## DESCRIPTIVE REPORT

*Registry No.* ..... H11847

*General Locality* ..... Approaches to Sitka

*Sublocality* ..... Vicinity of Biali Rock

Figure 10: Area of highly variable soundings

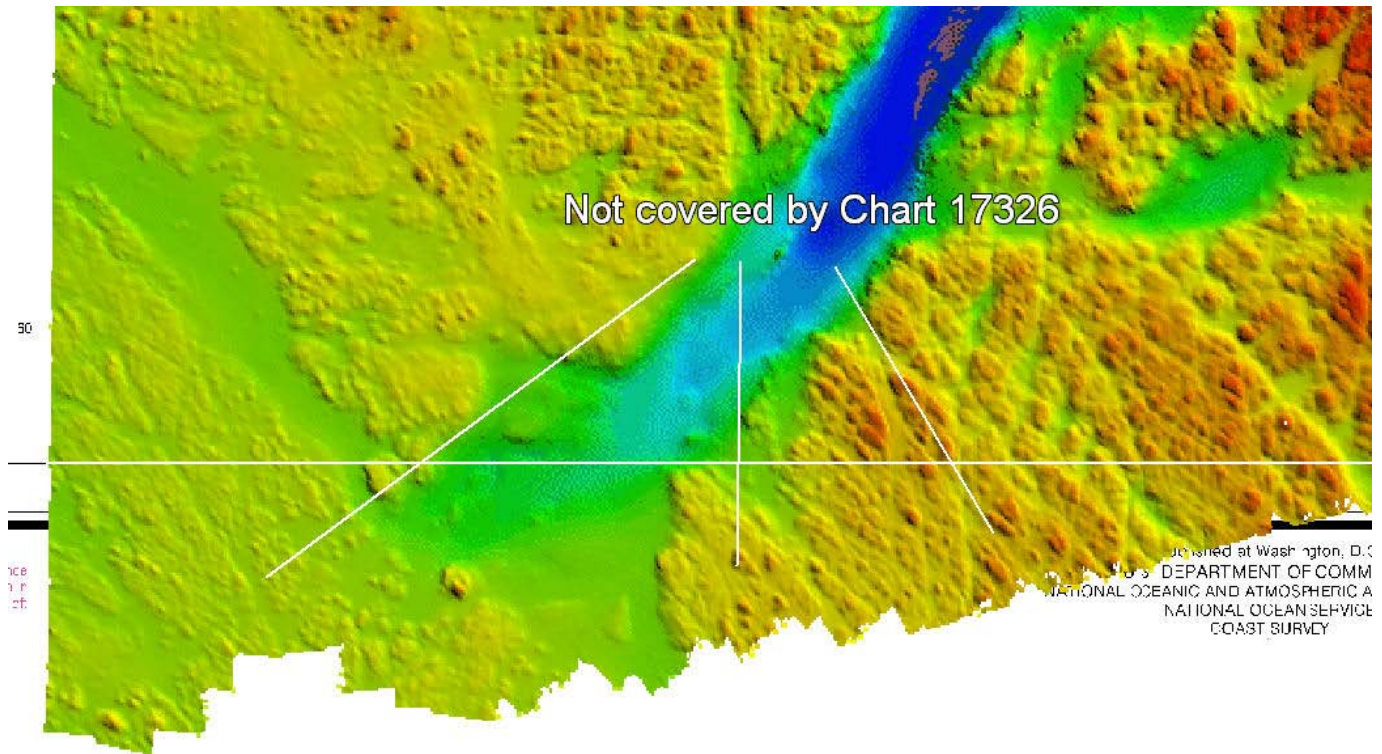
Depth comparisons made in CARIS with Chart 17326 agreed very well for the most part, with up to a 2 fathom difference with no general trend between survey sounding and charted depth, except as noted in Figure 11.<sup>12</sup>

Figure 10 shows the Northeast corner of the survey, the circled part is an area of vastly different soundings than what's charted. The Hydrographer recommends the chart be updated with the current survey to reflect the changes.<sup>13</sup> Except as noted previously, most of this area is deeper than the 10 fathom curve so the area is not hazardous, except around North Rock, which is charted correctly.

- <sup>11</sup> Concur. Also no comparison was done with chart 17328 because the soundings duplicate soundings of chart 17326.
  - <sup>12</sup> Do not concur. The surveyed depths varied greatly with the chart. HCell H11571 should supersede all charted depths.

Figure 13: Location of DTONs

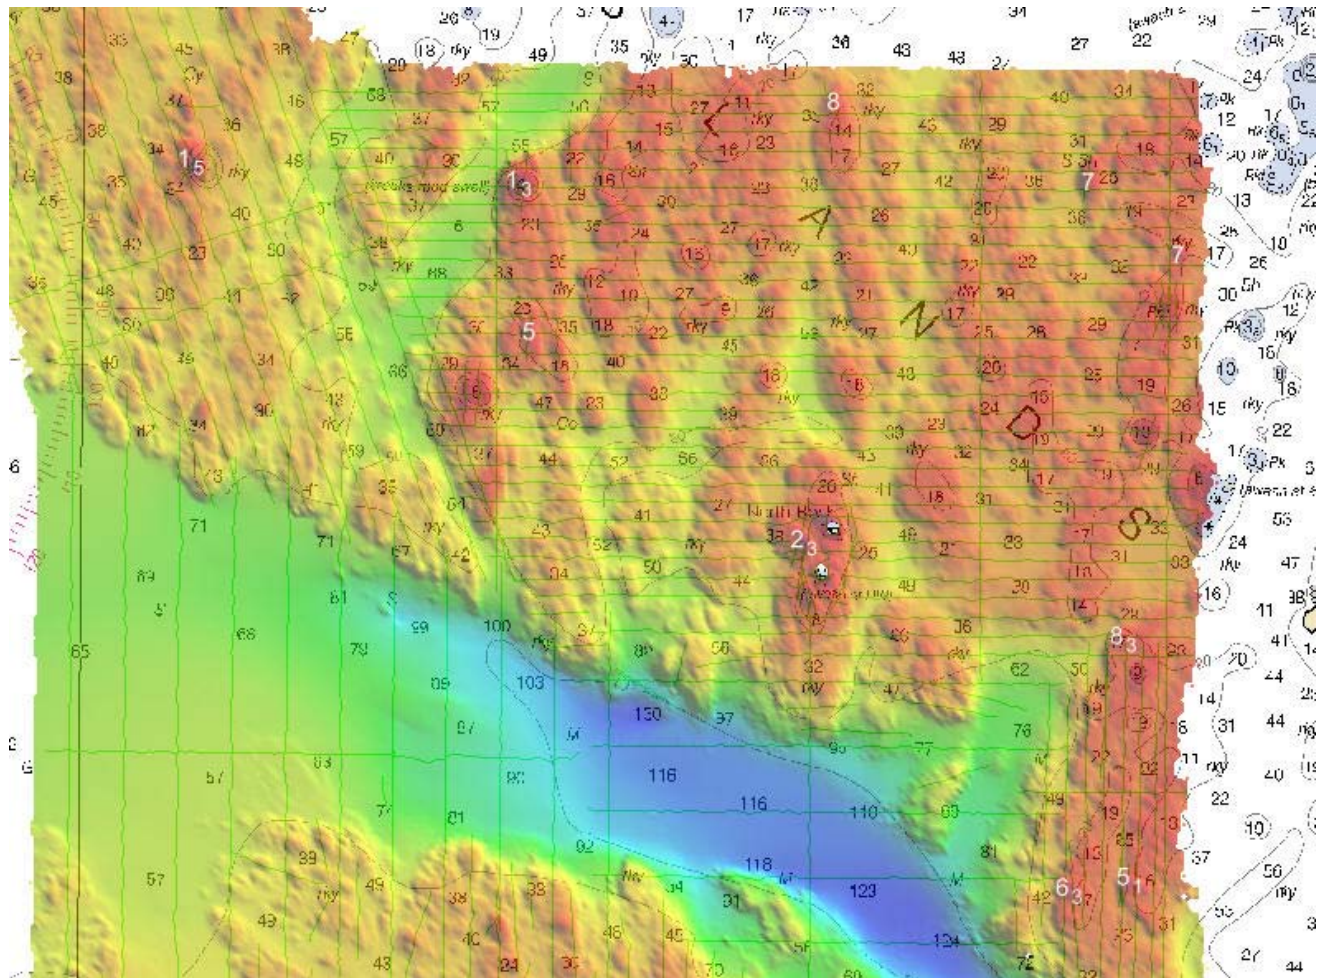
Ten (10) Dangers to Navigation (DTONs) were found on survey H11847, and reported to the Marine Chart Division via email on December 10, 2008. Although this DTON submission should have included ten (10) dangers, only nine (9) were actually submitted. One (1) of these DTONs was inadvertently omitted from original DTON report although the submitted sketch was correct. This missing DTON was reported to the Marine Chart Division via email on March 2, 2009.<sup>17</sup>

The original DTON submission packages are included in Appendix I. Descriptions of each DTON are included in the Survey Feature Report in Appendix II. Figure 13 shows the locations of each DTON:

- <sup>13</sup> Concur.
  - <sup>14</sup> Concur.
  - <sup>15</sup> Concur.
  - <sup>16</sup> Concur.
  - <sup>17</sup> This DTON has incorrect height. Upon inspection of the original data, the least depth in the area is 2.173 fathoms (3.97m). The other 9 DTONs submitted are correct and applied to the chart.

Figure 14: Location of AWOIS item (Chart 17326)

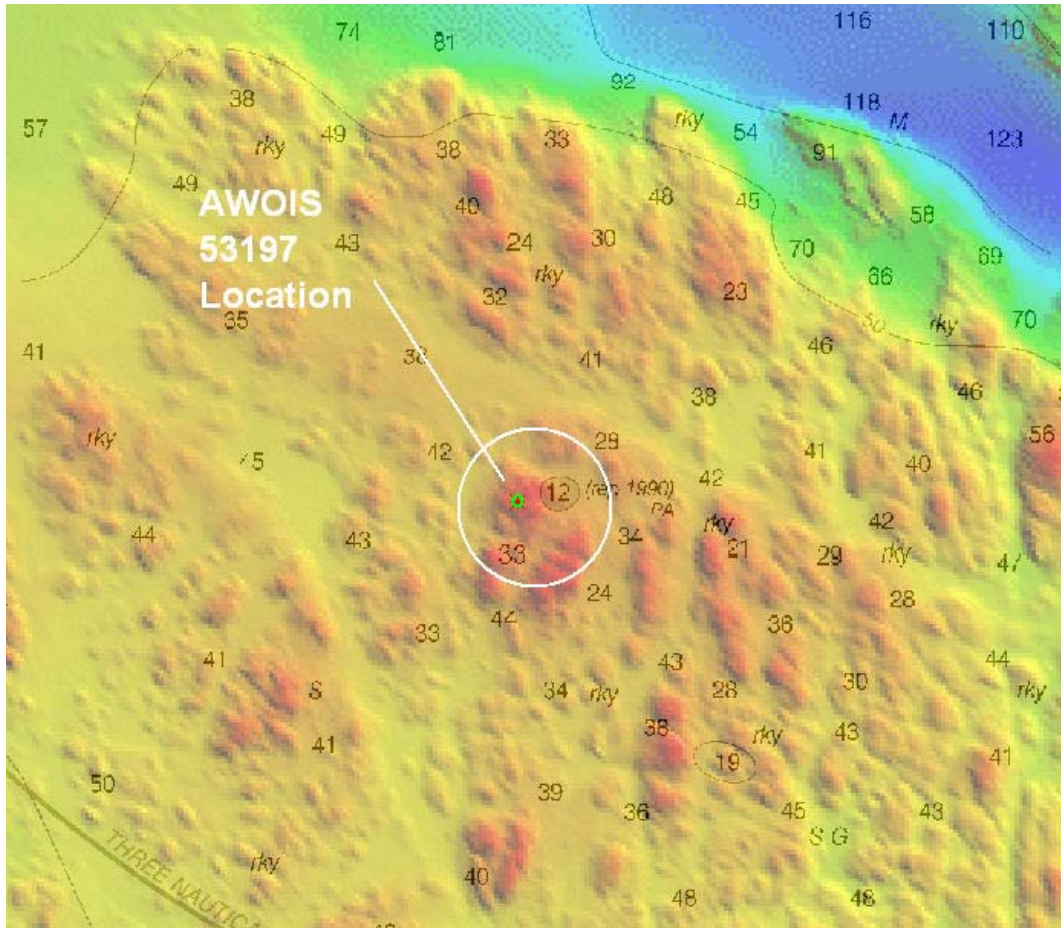
The charted 12 fathom sounding is slightly to the east of the actual least depth, which is 10 fathoms. The Hydrographer recommends the chart be updated to reflect the new depth/location of this shoal.<sup>18</sup>

- <sup>18</sup> Concur. This submerged rock/shoal AWOIS item location is represented in the data whereas the charted sounding is incorrectly located.

Figure 15: Location of AWOIS Item (Chart 17326)

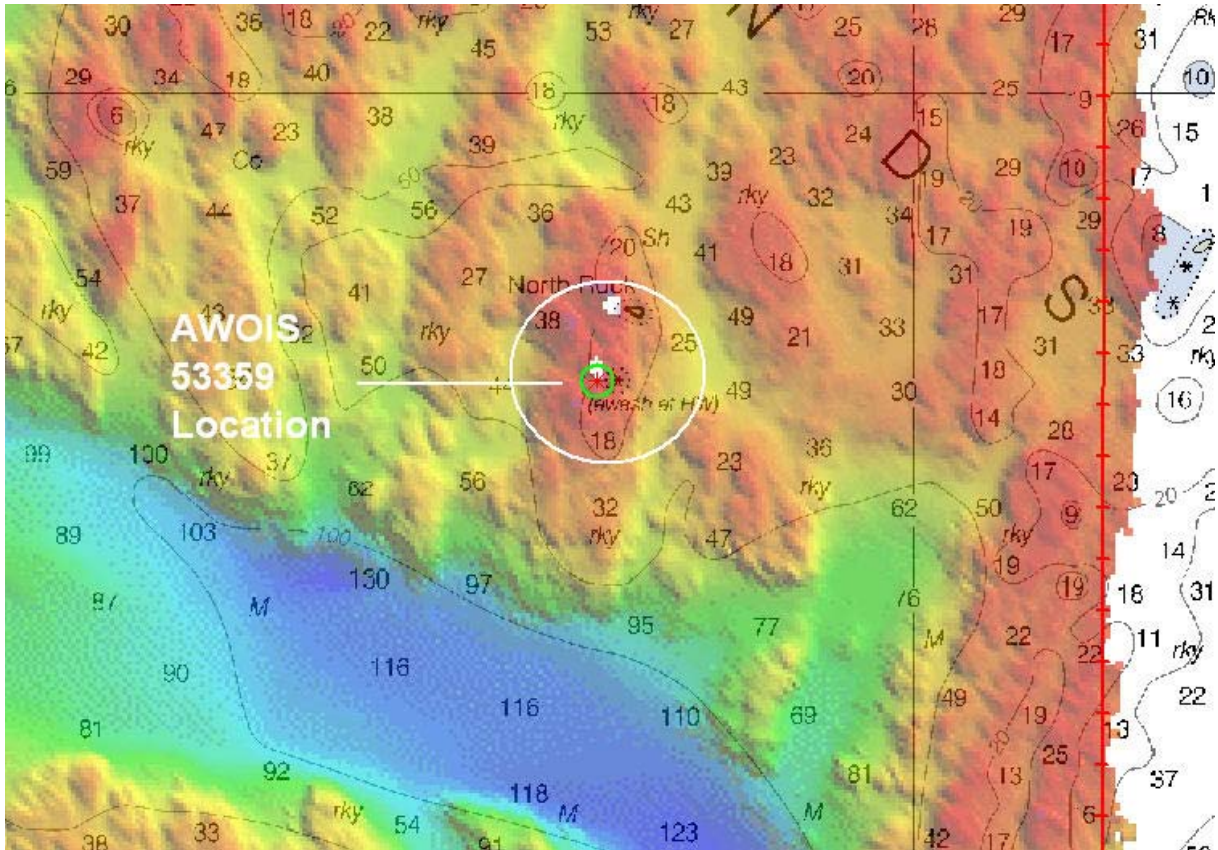
AWOIS Item 53359 is a charted rock located at 56°44'25" N 135°26'04" W, just south of North Rock, as shown in Figure 15.<sup>19</sup>

This feature was seen by both VBES Ceeducer and MBES. The Hydrographer recommends this feature be charted as per the digital data and Notebook.

- <sup>19</sup> Concur. AWOIS is now correctly charted.
  - <sup>20</sup> Concur.
  - <sup>21</sup> Concur.
  - <sup>22</sup> Concur.
  - <sup>23</sup> Concur.

Figure 1.1.1

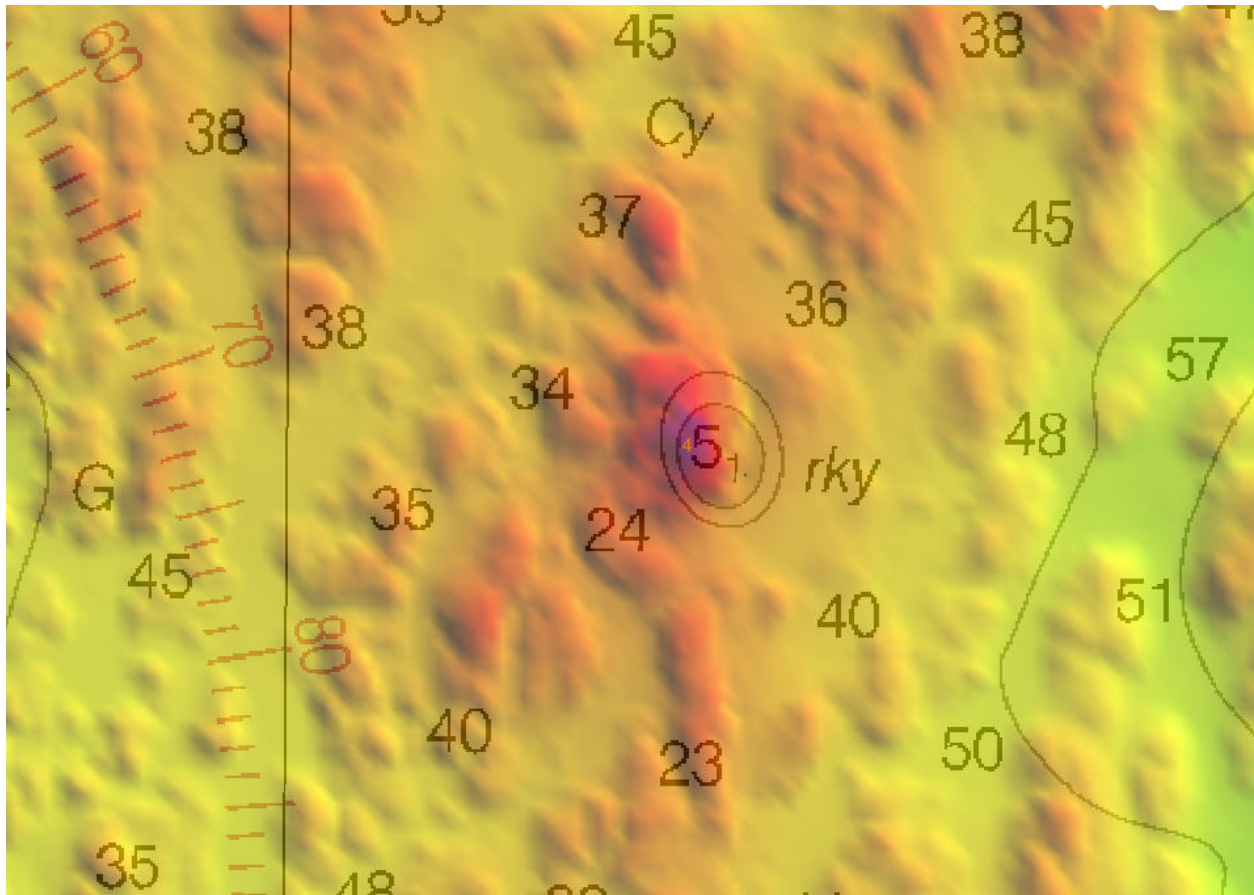
This H11847 DTON Report describes a new 4.0 m (2fm 1ft) submerged rock found during office review. This replaces the field "H11847 DTON Report #2" 3.5m (1 3/4fm) submerged rock which was actually noise in data.
